RE: Seattle Asian Art Museum in Volunteer Park

Dear Landmarks Preservation Board Members:

FSOP-Landmarks Board – Seattle Asian Art Museum in Volunteer Park - Comments

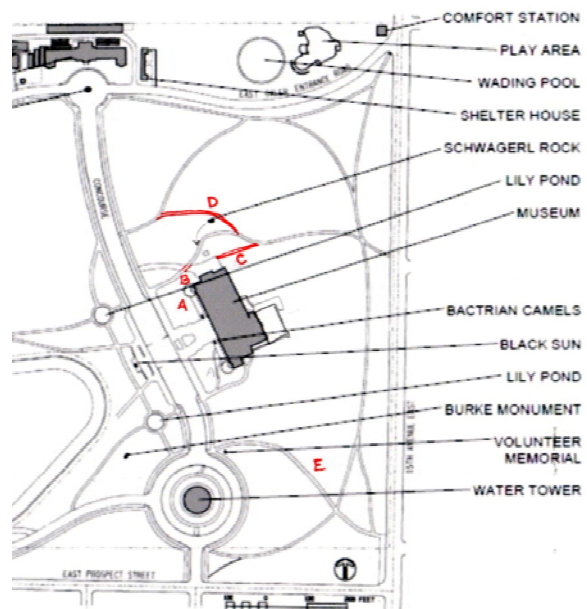
In commenting on the current proposal, the proposed interface of the building expansion to the east with the ground plane is of particular concern. There is an opportunity to reduce the scale of the building by setting it into the existing grade. Identifying a suitable interface of the building with the park needs to be defined from the perspective of how the building resides within the site. The landscape as described in the 1903 Olmsted Brothers report was to be of a “neat and smooth style of landscape gardening throughout, thus harmonizing with its surroundings.”

The museum proposal to further extend its footprint into the park by grading a terrace extension 20-26 feet eastward from the proposed 35-foot addition is contrary to preserving the park landscape. It creates a totally new landscape that is not compatible with the historic character of the east side of the park as a greensward with a gently sloping lawn interspersed with trees and planting. The museum needs an egress door on the lower level, but it does not need a terrace or a floor-to-ceiling bank of windows. Having entertained a range of aspirations for what the addition might provide, we now more clearly recognize that the east side of the building sits in an informal natural landscape compared to the formal character of the highly designed west entry. Therefore, we find programmed space added to the backside of the building to be inconsistent with the historic site. Rather, there should be a more focused examination of the building placement within the existing landscape and how it serves as a backdrop for the park in the least intrusive manner.

As such, the transition to the greensward should begin immediately at the eastern edge of the museum building.

The proposed new addition to the south and east façades is generally an unbroken mass, that will loom over the park. Identifying ways to modulate this scale would be very beneficial in reducing the impact on the park. Since the SE corner of the expansion is the tallest point from the existing grade and, as currently designed, is topped with a large mass without relief of fenestration, providing for planting to screen the building along the south and east would be beneficial.

– Current park plan

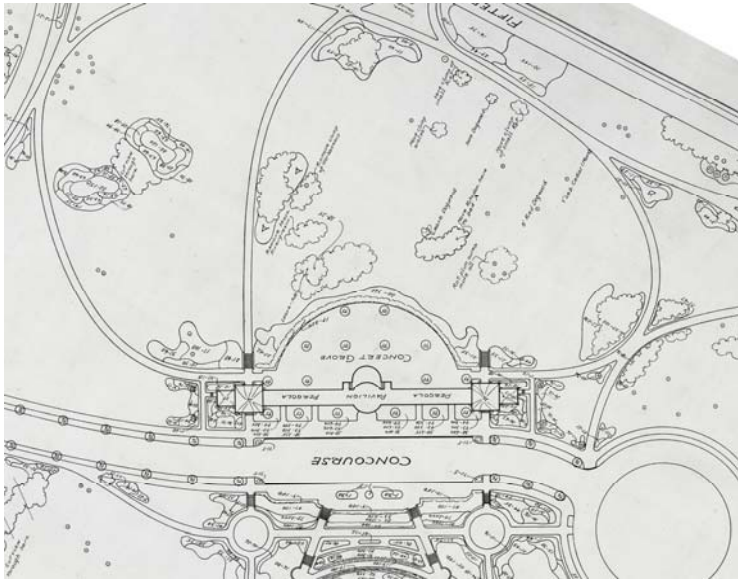
- A. In the lawn in the front (west side) of the museum, the landscape architect proposes to install a new ADA path through the north Hoggson lawn and to reconfigure the existing one in the south lawn to be compliant. We support making the south path compliant, but do not think that inserting a path in the north lawn is appropriate, since it was not part of the Hoggson plan. Inserting intrusions just for the sake of creating symmetry does not meet the intent of Federal Standards. The path on the south side requires less grade change and thus can sit more discreetly in the landscape.

- B. The existing path that connects the north lawn of the museum to the northeast park greensward, is an important connector within the park and provides a typical Olmstedian experience of transitioning between spaces and being able to see through and be drawn to the next space. The upper section of this path is part of the Hoggson plan, which reconnected the original east-west Olmsted path when the museum was built in 1932.

The museum proposal takes over this path as access to the elevated ADA ramp for staff. We believe that both needs can be met, by having the path divide to join the ramp and allow the park path to continue down into the park. Retaining this path is highly desirable.

- C. Reestablishing the east-west Olmsted path is important for continuing access from the east side of the park to the heart of the park in front of the museum. The Hoggson plan was laid out to retain this important east-west connection, but over the years it has, in effect, been blocked by parking and dumpsters.

There is an opportunity to reinstate this historic connection, not as a main ADA path, but as an optional path connection so that park users have a convenient and direct way to get from the east side of the park to the front of the museum. The dumpsters are proposed to be placed out-of-sight behind the loading dock and there is no need for a parking lot to

take up park land when there is plenty of parking elsewhere and nearby in the park. With the reconfigured loading dock area, the path can share the driveway which will have relatively limited use on any given day. Since it won't be a main path it can easily be blocked off when special events are happening that would require exclusive museum use.

- D. The proposed ADA connection north of the museum in the northeast greensward by itself takes park users far out of their way, but in combination with the existing and reinstated path connections described above (B. and C.), it could potentially provide an acceptable ADA route if the grading and landscape impacts are properly addressed in laying out the path. Further analysis of circulation routes in the park needs to be done before implementing this new path connection (see E. below).
- E. Resolving ADA access from the SE corner of the park, where the bus stops are that serve the park and museum, needs more attention. Improving such access and determining how it should go through the park is a critical need in addressing pedestrian and wheelchair access.
